Groundwater Application Review Summary Form

Application # G- 18665

GW Reviewer D. BOSCHMANN Date Review Completed: 05/08/2018

A. GENERAL INFORMATION: Applicant's Name: Rock Creek Ranch Inc. County: Harney

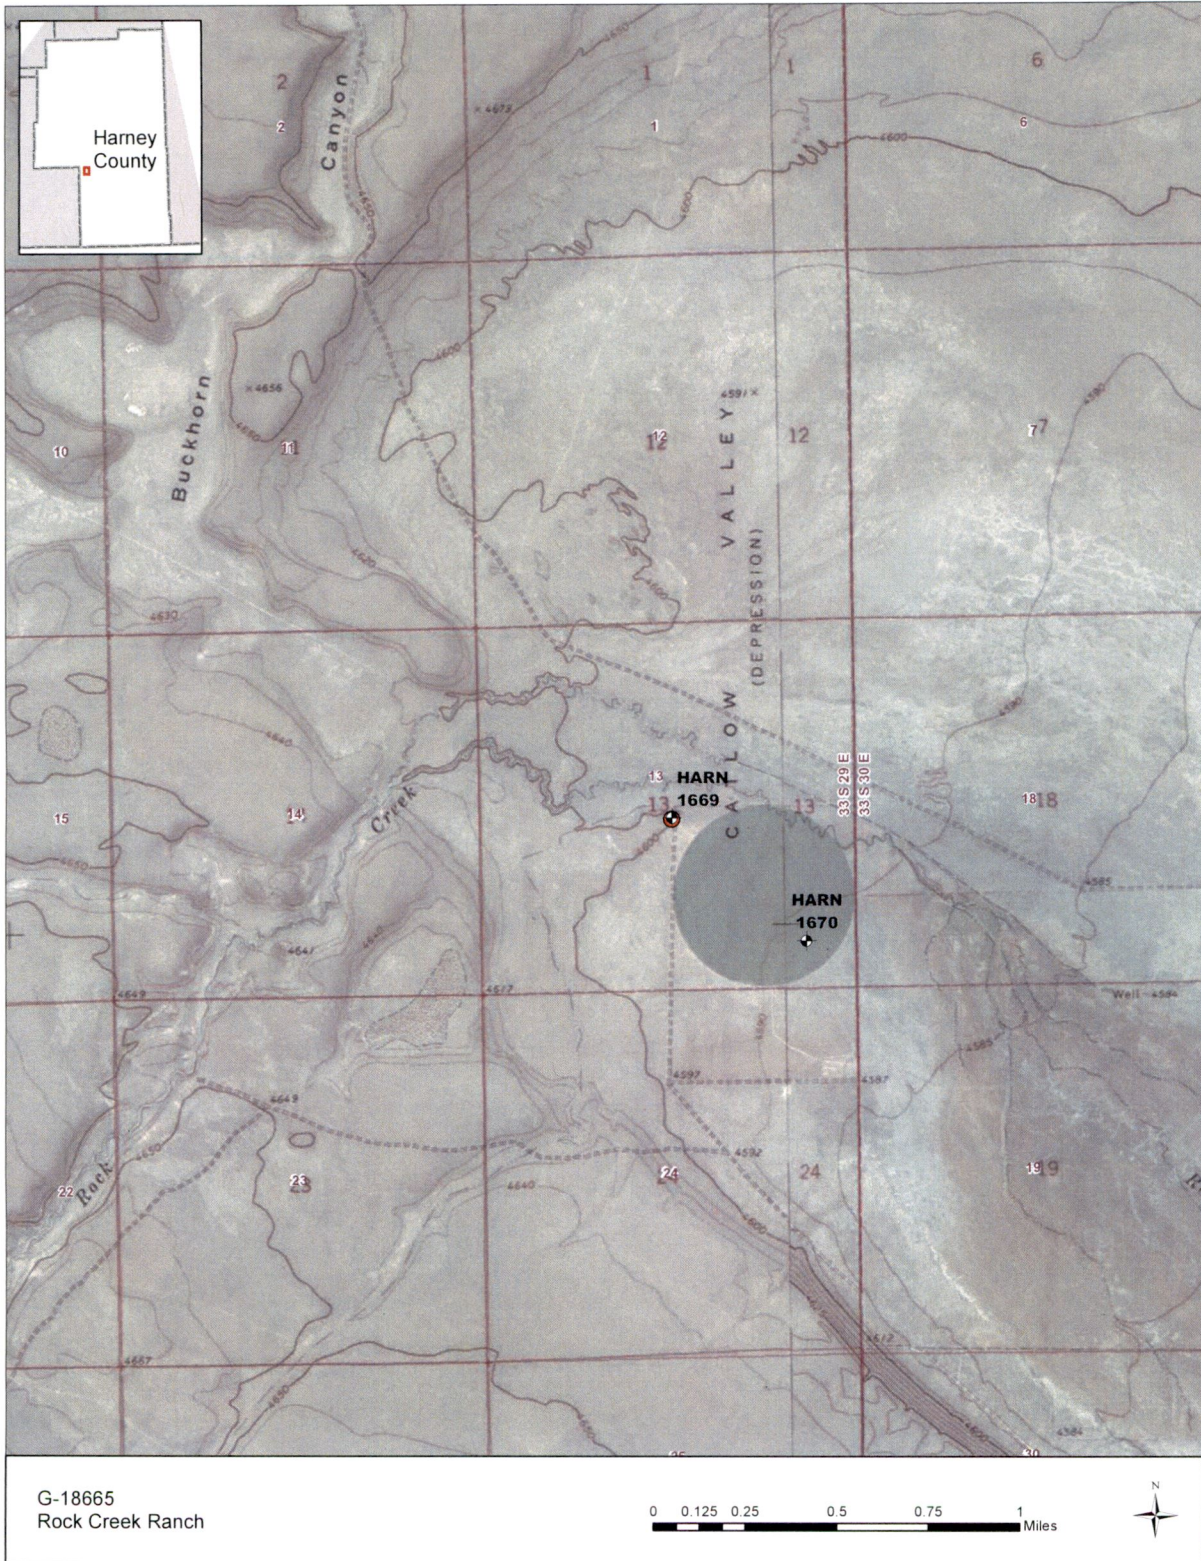
D3. **THE WELL construction deficiency or other comment is described as follows:** _____

Insufficient seal depth (10 foot cement seal).

D4. **Route to the Well Construction and Compliance Section for a review of existing well construction.**

Water-Level Trends in Nearby Wells

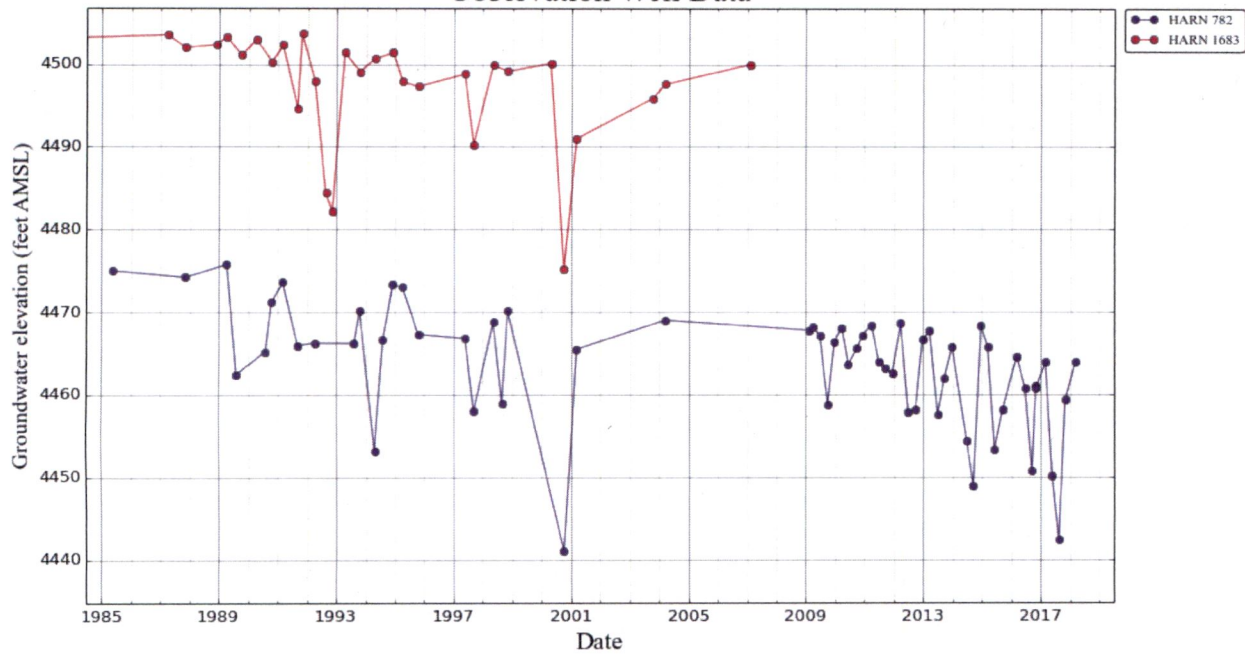
There are two State Observation Wells in the Catlow Valley. The State Observation Well with long term data closest to the proposed well is inactive State Observation Well 1150 (HARN 1683) located in T33S/R31E-sec 31; about 8 miles southeast of the proposed well; which has a period of record from 1987-2008. The other is State Observation Well 1151 (HARN 782) located in 33S/31E-8; about 8 miles east-northeast of the proposed well; which has a period of record from 1987-current. Water level trends in both wells seem to indicate a slight rate of decline over the period of record (see attachment); however the relative contribution of long term climate cycles and groundwater withdrawals to this decline cannot be determined.
